## **ADDENDUM NO. 4:**

Date: July 7, 2015  
Project: Alberta Technology Center  
Owner: The City of Tuscaloosa  
Owner's Project No: A15-0513  
Architect: Ward Scott Architecture, Inc.

This Addendum forms a part of the Contract Documents and modifies the original Bid Documents dated June 22, 2015, as noted below.

**A701**

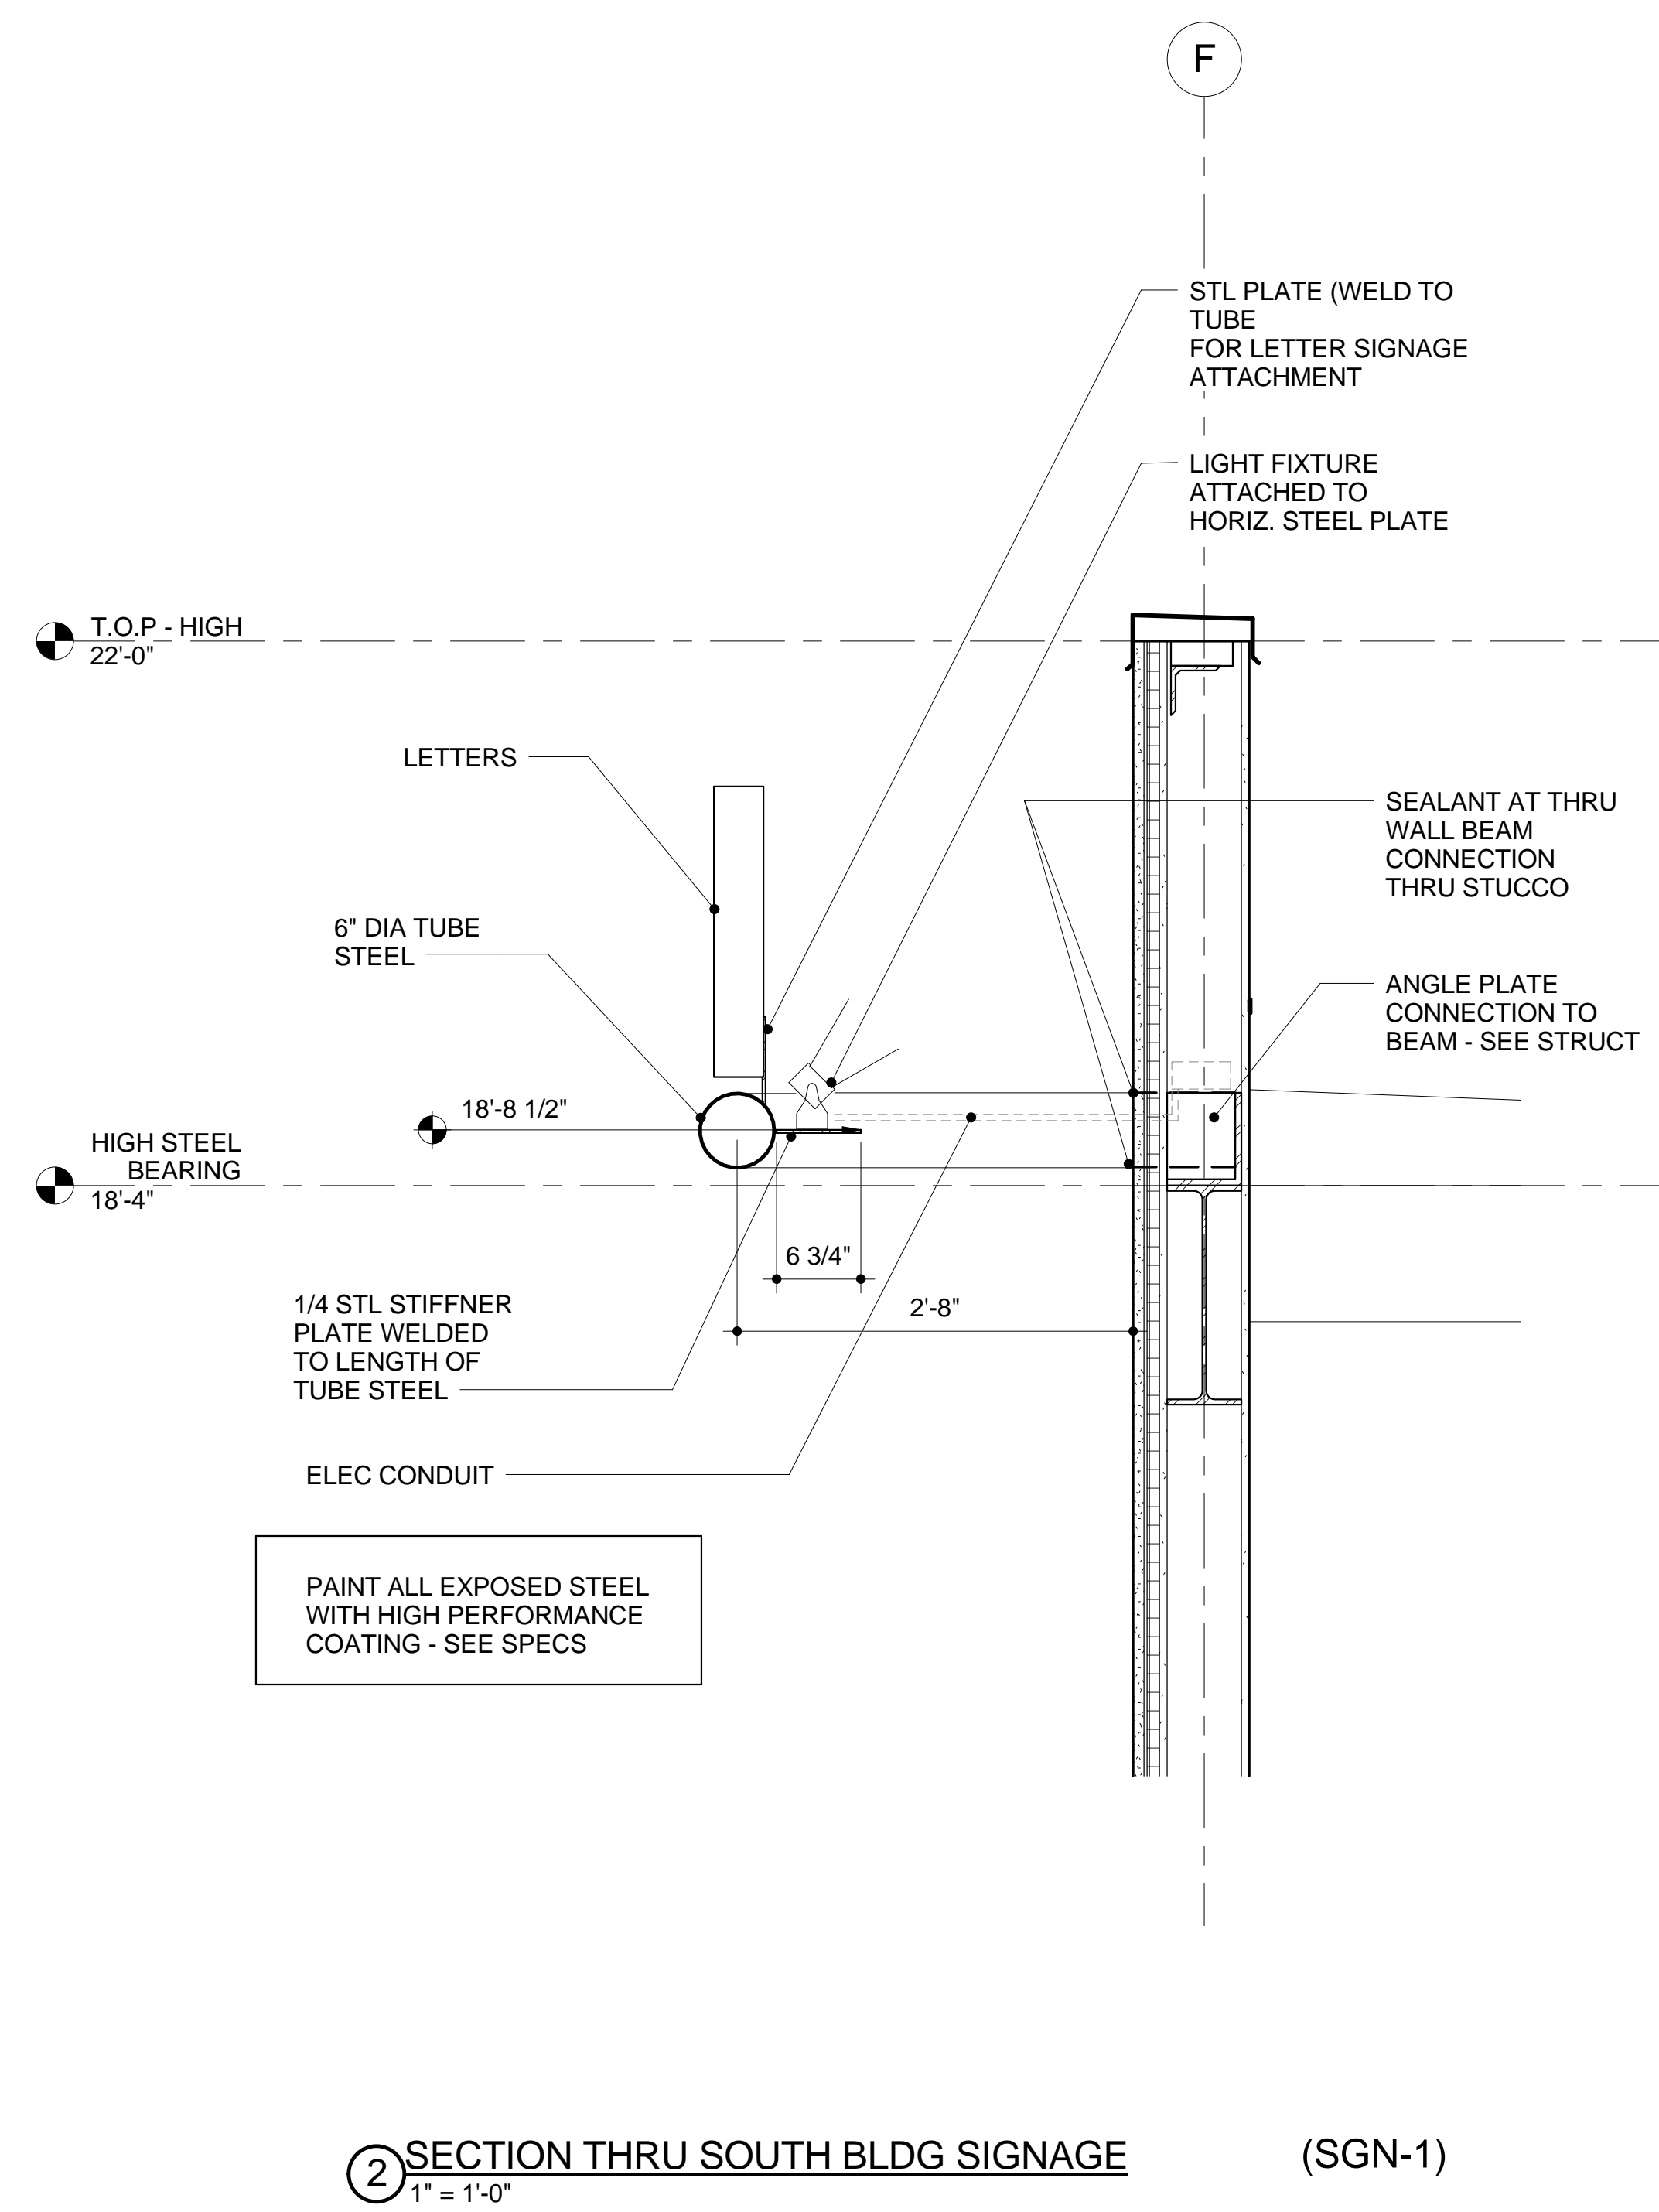
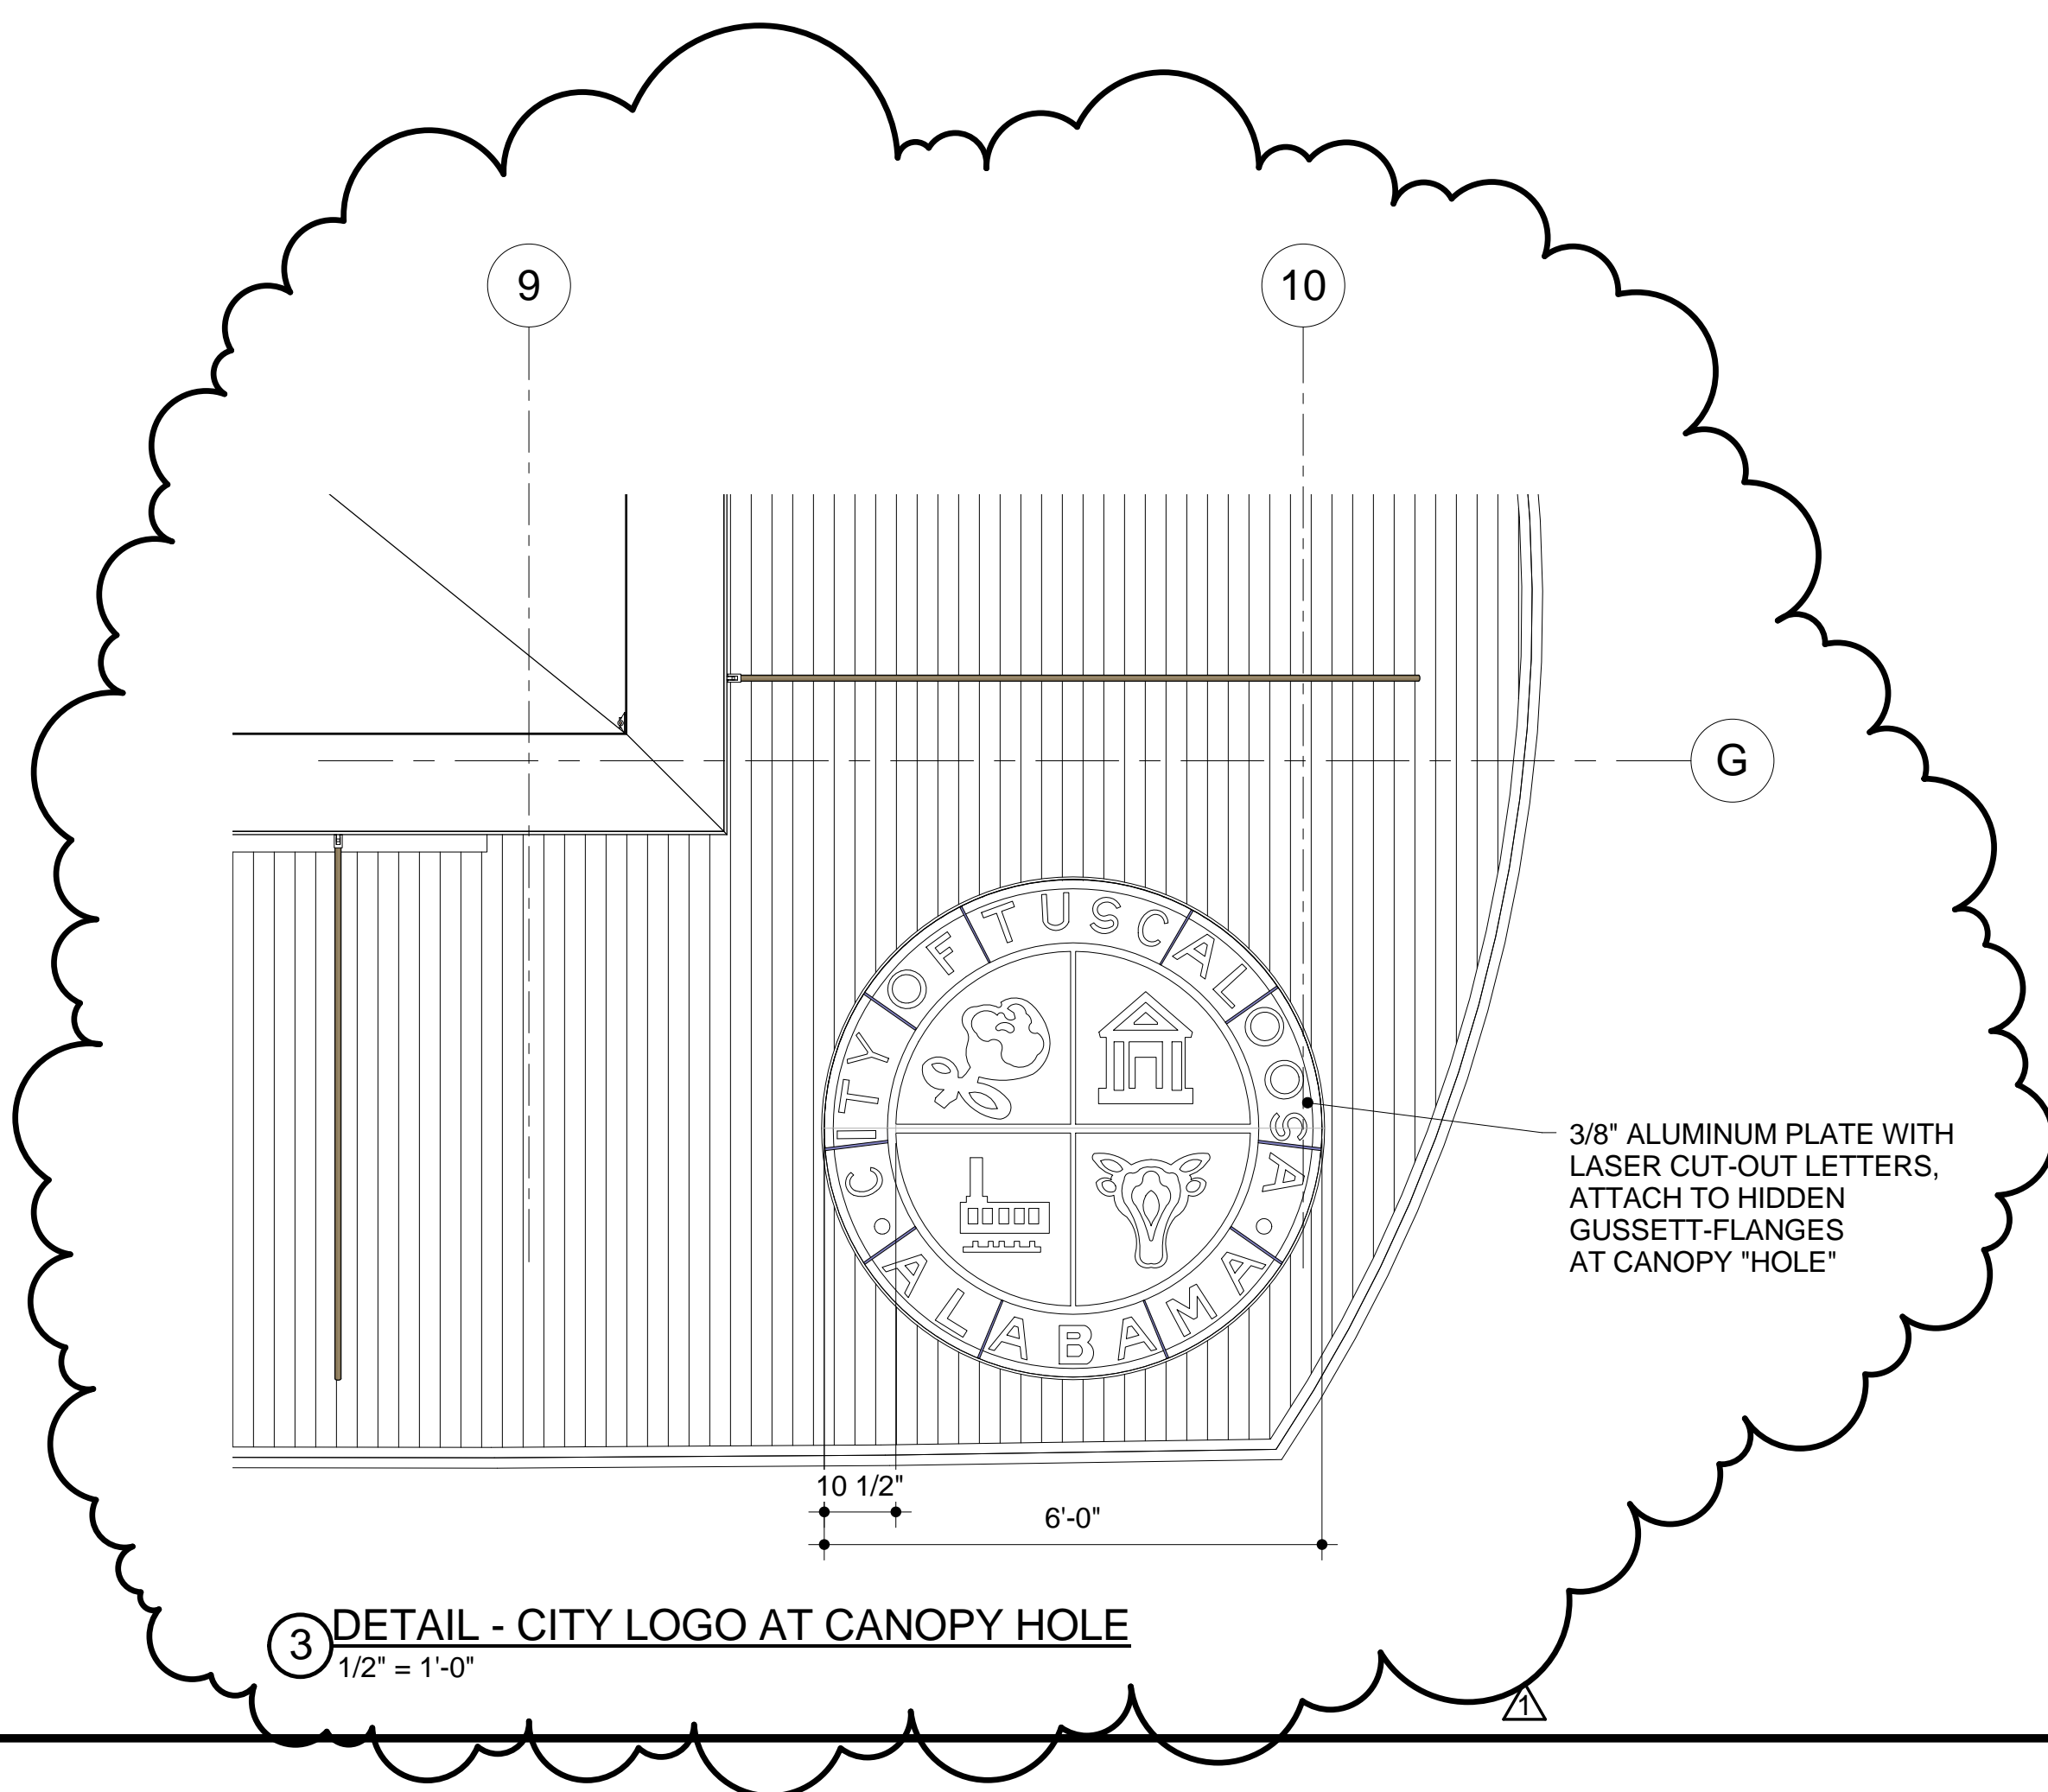
- A. The following sheets have been added:
  - 1. Sheet A502 Upper Reflected Ceiling Plan
  - 2. Sheet A702 Interior Kiosk and Details
- B. The following sheets have been modified:
  - 1. A101 Floor Plan.
    - a. Two presentation niches have been added at Vest 101 – See elevation on 3/A702. Note additional electrical puck fixtures and switches by engineer during submittals. Puck Basis of Design: Modalight, Mezo3.
    - b. Add General Note: install 10 corner guards per Architect.
  - 2. A101 Equipment Plan. Item 17 Interactive Video Wall to be purchased by (OWNER-IT), not by GC as previously indicated.
  - 3. A701 Exterior Signage. New Aluminum plate emblem added to hole in south canopy.
